BID
ADDENDUM NO. 3
TO
CONTRACT DOCUMENTS
AND
TECHNICAL SPECIFICATIONS
FOR
2019 BOND REFERENDUM
CAPITAL IMPROVEMENTS
AT
MAMARONECK HIGH SCHOOL
PHASE 2
NYSED #66-07-01-03-0-001-039
BID # 20/21 – MUFSD-00

Mamaroneck Union Free School District
1000 West Boston Post Road
Mamaroneck, NY 10543

LAN Job #4.1092.72.06
January 7, 2022

DUNNAGE PAINTING NOTE:
GC TO SCRAPE, PRIME & PAINT EXISTING STEEL DUNNAGE PER THE DUNNAGE PAINTING NOTE ON DRAWINGS A0.01 & A0.02. REFER TO SPECIFICATION SECTION 099113 - EXTERIOR PAINTING FOR ADDITIONAL INFORMATION.

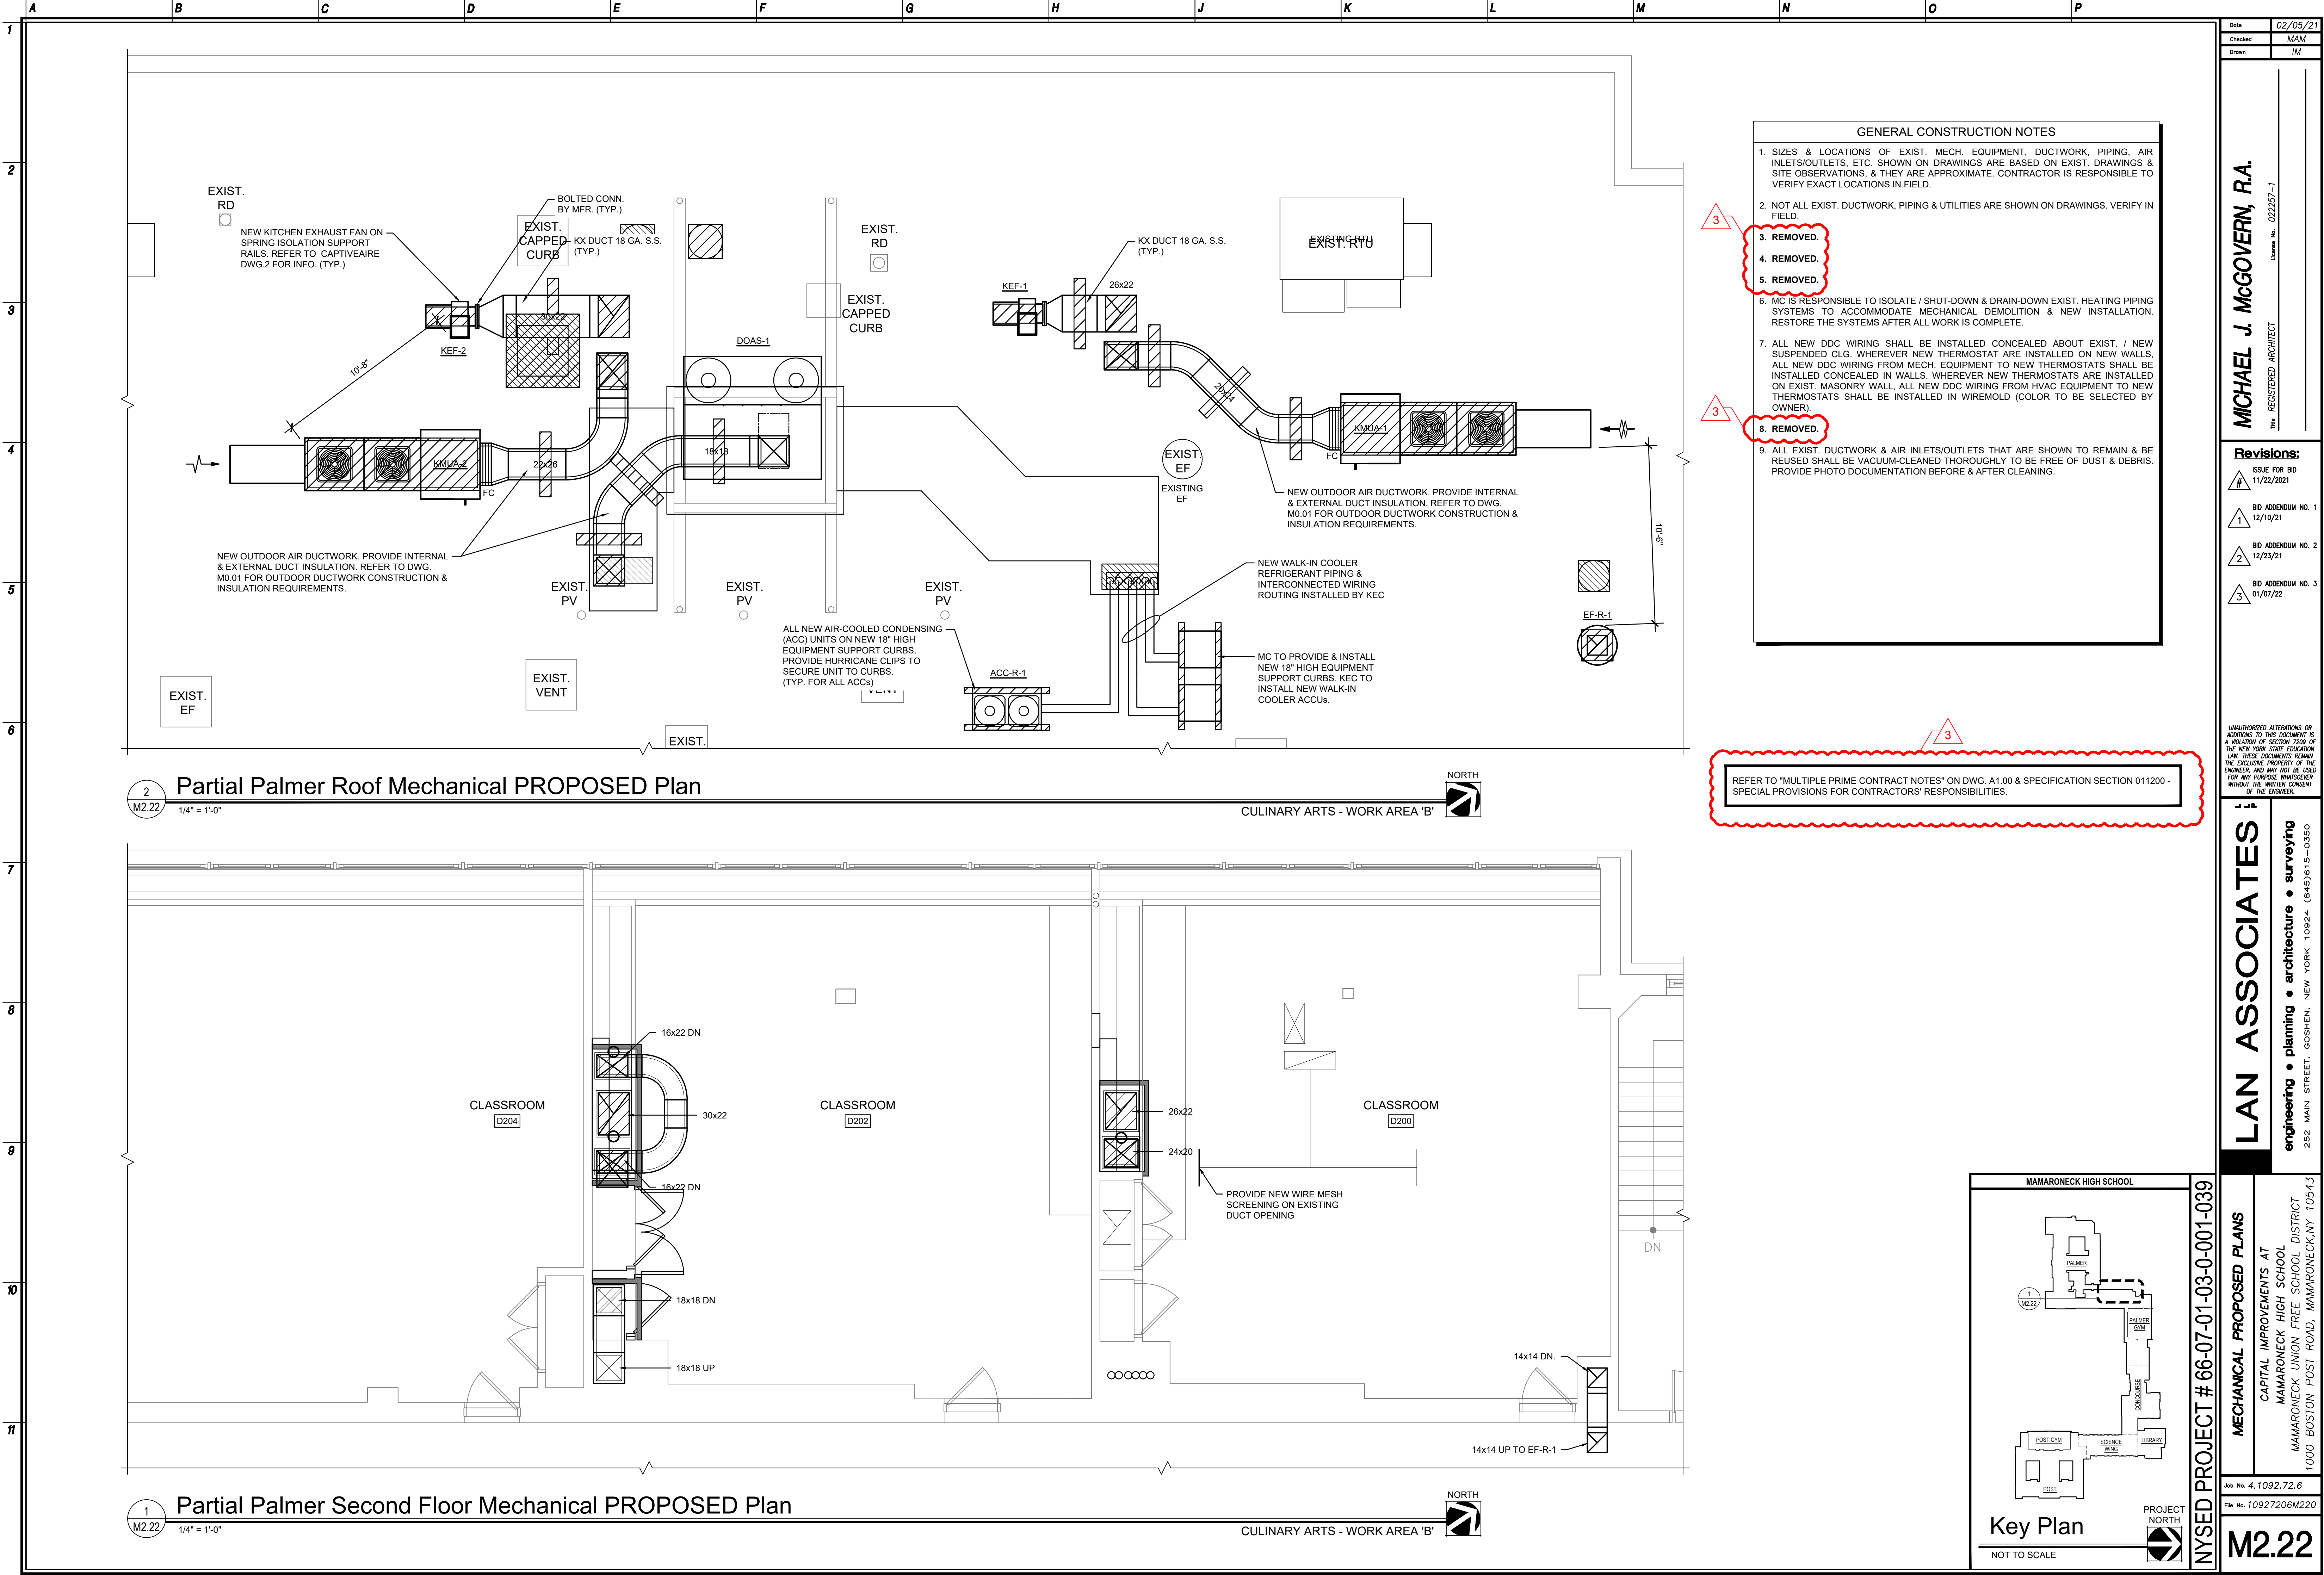
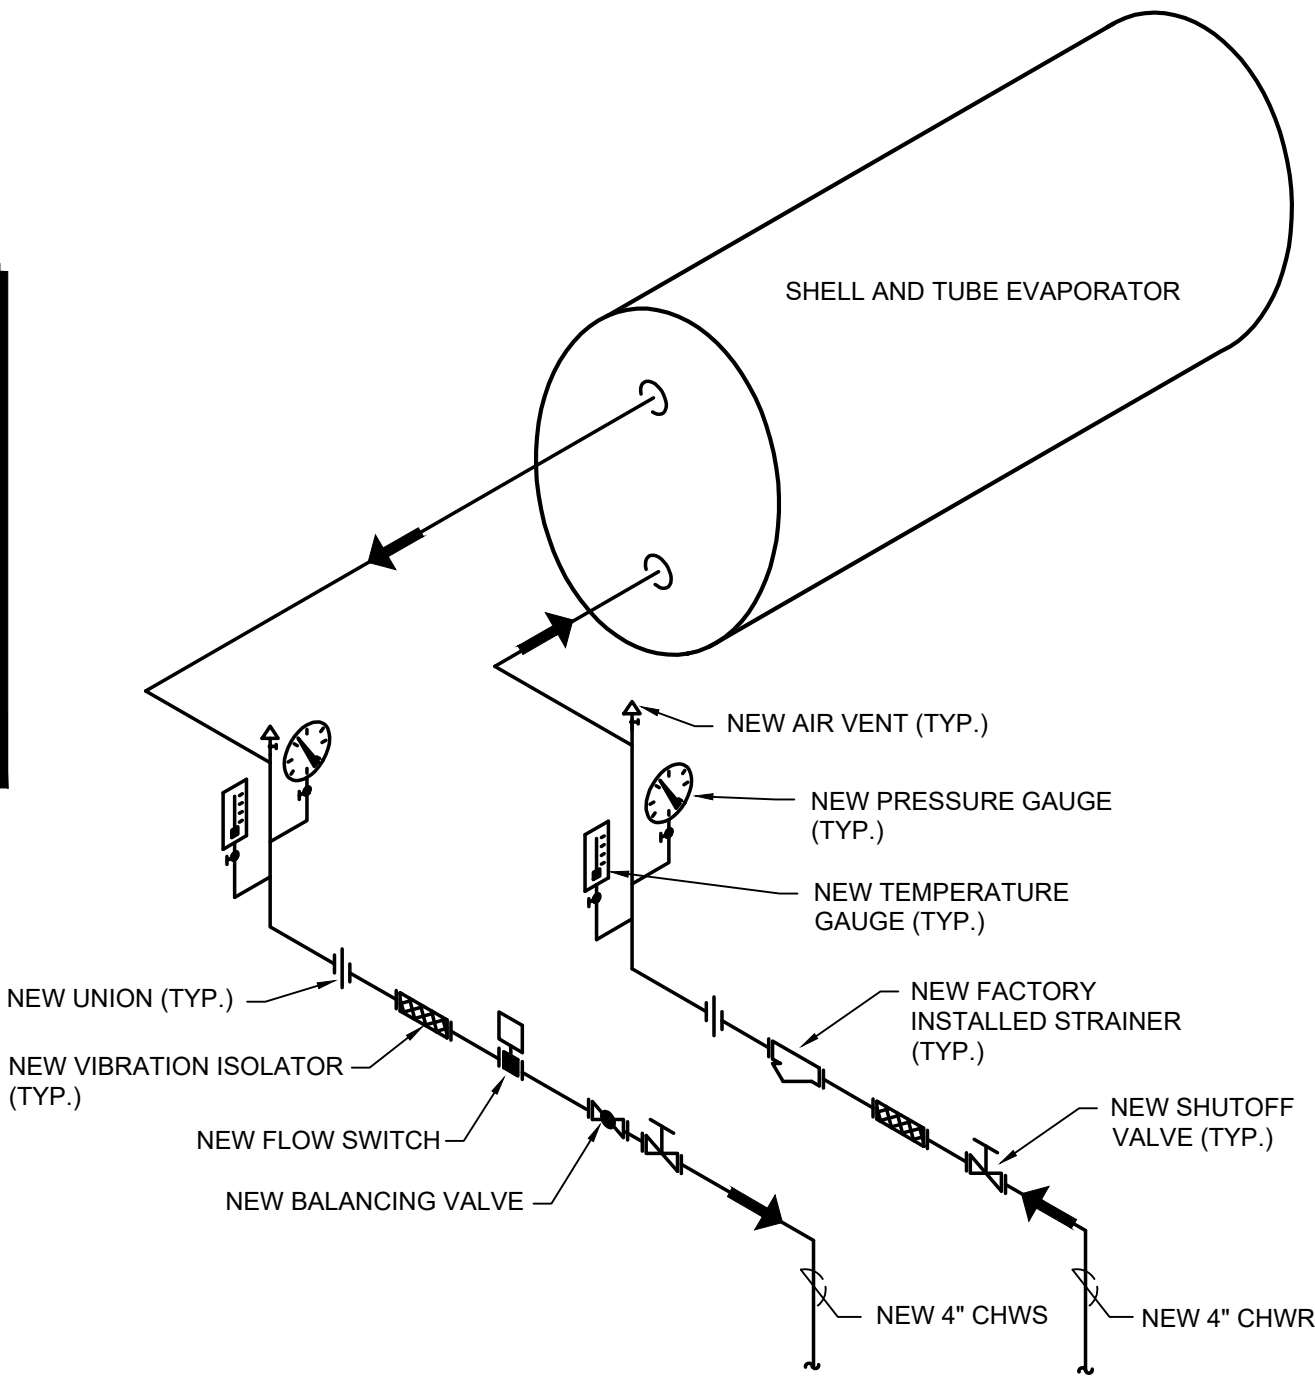
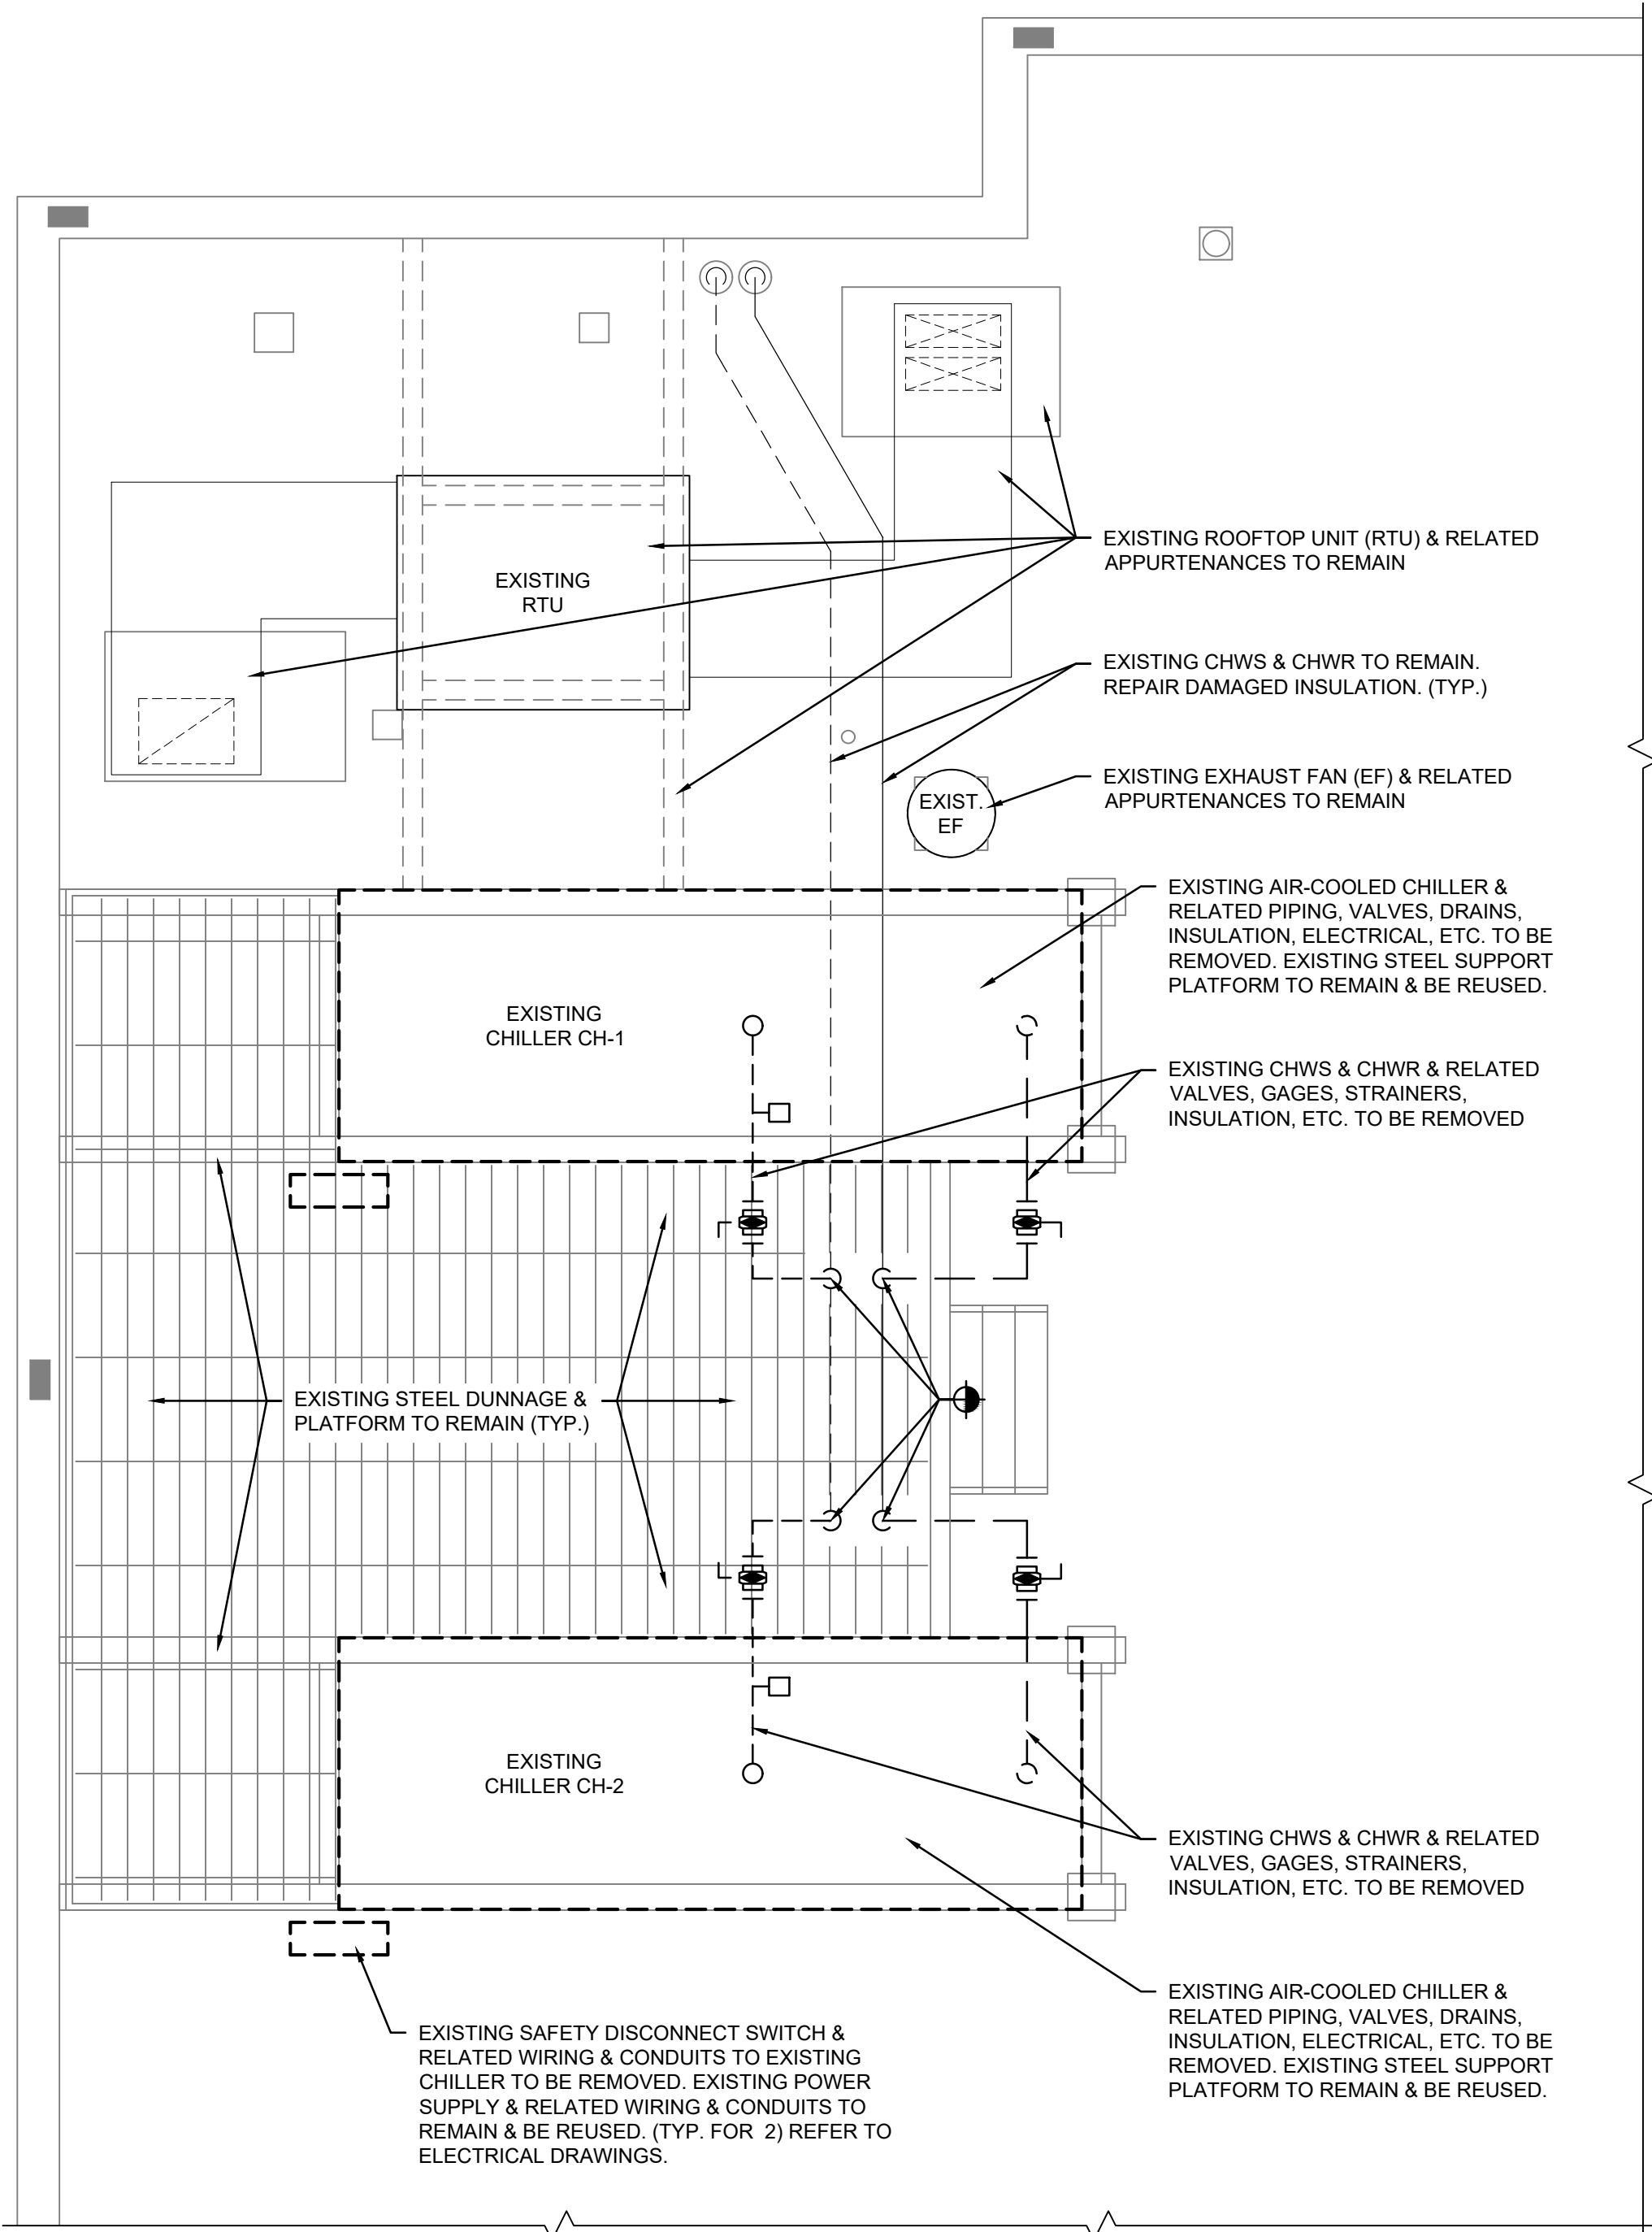
- 5 Question: M2.71 – Does the chilled water loop need to be refilled with glycol. If so what's the type and mixture percentage?
- Response: There is no glycol in the system.

- 7 Question: As discussed in the walkthrough the Existing Dunnage Scraping and Painting is to be performed by the GC. After review of the following Contract Drawings, M2.71 includes the following note, "Insert Note GC to scrape and Paint Steel Dunnage" and in addition refer to M2.91, Demo and Construction Key Notes 1, 2 & 4. Please confirm if any portion of this work including Alternate 6B-2 is to be provided by the General Contractor.

- Response: Painting of the dunnage shall be by the GC. Refer to updated drawings A0.01, A0.02, M2.71, and M2.91.
- 8 Question: Please refer to Contract Drawing M2.11, FD/SD is indicated on the plan in several locations. Please refer to M0.01 where FD/AD and FSD/AD symbols are indicated. Please clarify the desired assembly to be provided on M2.11.
